1 APPLICATION SUMMARY

Application information		
Address	17 Courtney Drive, UPPER COOMERA QLD 4209	
Lot and plan	Lot 182 RP156422,	
Site area	33,410m ²	
Type of development and proposed use	Reconfiguring a lot (1 into 2 lot subdivision)	
Categories of development and assessment	Code assessment	
Properly made date	18 January 2023	
Decision due date	17 April 2023	
Applicant and Applicant's consultancy team	Mo Chen and Ying Yuan – Applicant Elevate Development Solutions Pty Ltd– Town Planning Trilogy – Survey and Subdivision Plan Taylor Environmental – Effluent Management Eldon Botcher Architects – Bushfire Management Natura Consulting – Ecological Assessment	
Owner details	Mo Chen and Ying Yuan	
City Plan version	Version 9	
Zone / Precinct	Rural residential	
Overlays	- Airport environs - Procedures for Air Navigation Services, Aircraft Operational (PANS-OPS) surfaces. - Bushfire hazard area. - Dwelling house overlay area. - Environmental significance –priority species, Matters of state environmental significance and Koala habitat areas - Environmental significance – wetlands and waterways - Landslide hazard overlay

The purpose of this report is to assess an application for a Develop

Figure 2: Upper Coomera (Courtney Drive) Sub Precinct Mapping (Source: City Plan Version 10)

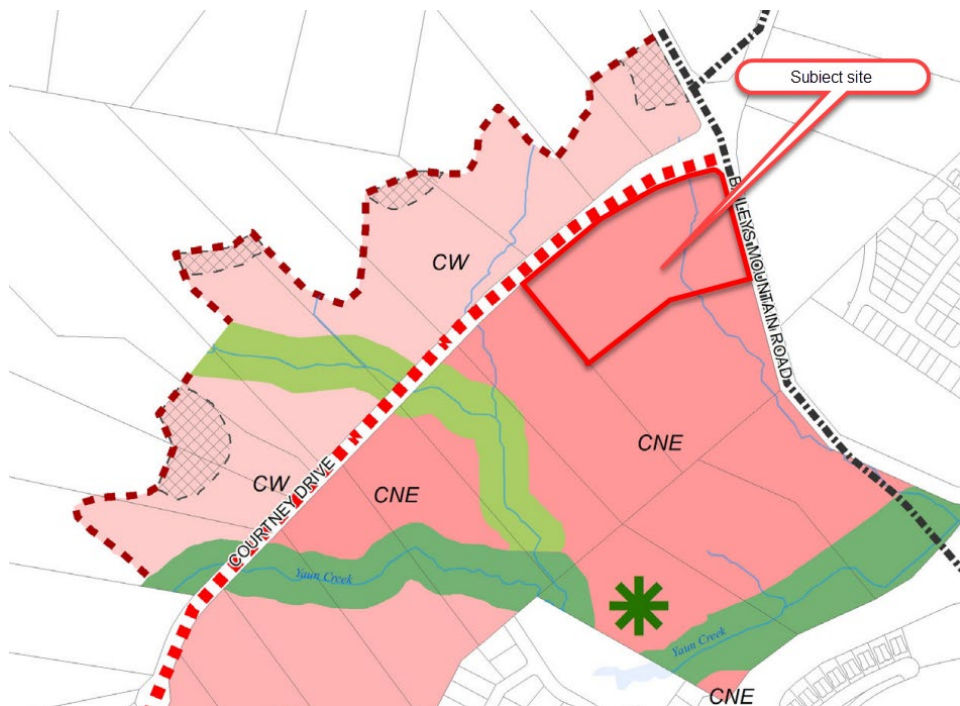
On 28 February 2023, Council adopted City Plan Version 10 to commence on 4 July 2023. City Plan Version 10 makes amendments to part of the Courtney Drive area. Specifically, the zoning of the subject site is identified to be changed to Emerging community zone within the Upper Coomera (Courtney Drive) precinct, and Courtney north-east sub precinct. Once commenced, this precinct (and subsequently the entirety of the subject site) anticipates a residential density of 19 to 23 dwellings per net hectare. In accordance with s45(8) of the *Planning Act 2016*, an assessment manager is able to give weight to an amended statutory instrument if the statutory instrument is amended after the development application is properly made, but before it is decided. As such, City Officers have given consideration to City Plan Version 10 to determine future planning direction for the Upper Coomera (Courtney Drive) area, which then also impacts the standard of infrastructure required to service the area for future development.

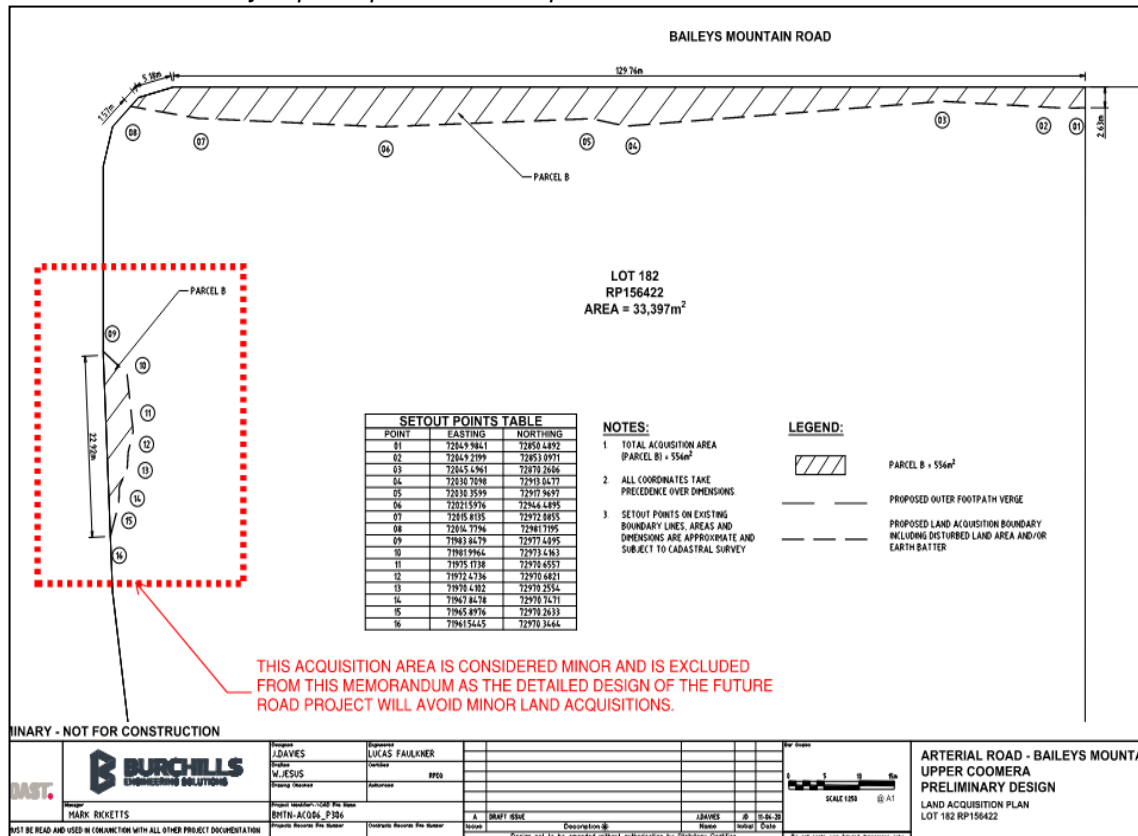
The proposed development triggers the dedication of land required for the future upgrade of Baileys Mountain Road and includes:

- Dedicate 503m² of land adjacent to Baileys Mountain Road for future road widening in accordance with City of Gold Coast plan titled Arterial Road – Baileys Mountain Road Upper Coomera Preliminary Design Land Acquisition Plan, drawing number: 277144.P306 (see Figure 6).
- This application includes trunk roadworks with an estimated value of \$57,300. While timing is uncertain, this is likely to be payable/offset by the City in the FY 2022-23. The trunk transport infrastructure work is identified in the LGIP and Power budget.
